MODEL: i9100, i6500, i6100

No.: PRNT-1230
(Q-12E-0067)
Date: 25.07.03

LOCATION: PURGE UNIT

SUBJECT: SCREW CHANGE

Tapping screw securing the wiper cleaner ass'y to the purge unit

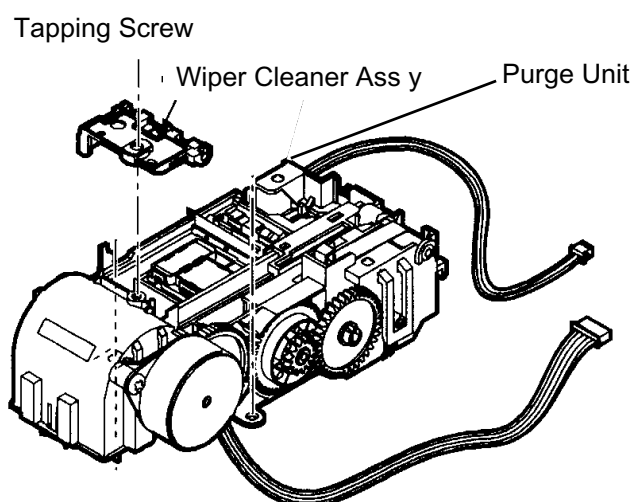
For quality improvements, the tapping screw securing the wiper cleaner ass'y to the purge unit has been changed.

- Old: M3 x 6 B-tight screw

- New: M3 x 8 P-tight screw

The old and new screws are NOT compatible.

With the previous screw, a crack was found on the boss of the purge unit where the wiper cleaner was secured.

To prevent cracks, the screw has been changed from B-tight to P-tight.

1. Use the removed screw.
2. If the removed screw is missing, be sure to use the same type of screw as the original screw.

- (1) Use the removed screw in fastening the replaced wiper cleaner ass'y.
- (2) If the removed screw is missing, use the same type of screw as the original screw.

Reason: In securing the wiper cleaner ass'y to the purge unit, the boss hole is tapped by the screw. If a different type of screw is used, the original screw thread may be damaged, and the screw cannot be fastened.

- (1) Use the removed screw.
- (2) If the removed screw is missing, either the old or new type of screw can be used.

Reason: There is no screw thread inside the boss hole, as the service part purge unit is unused (new from the inventory).
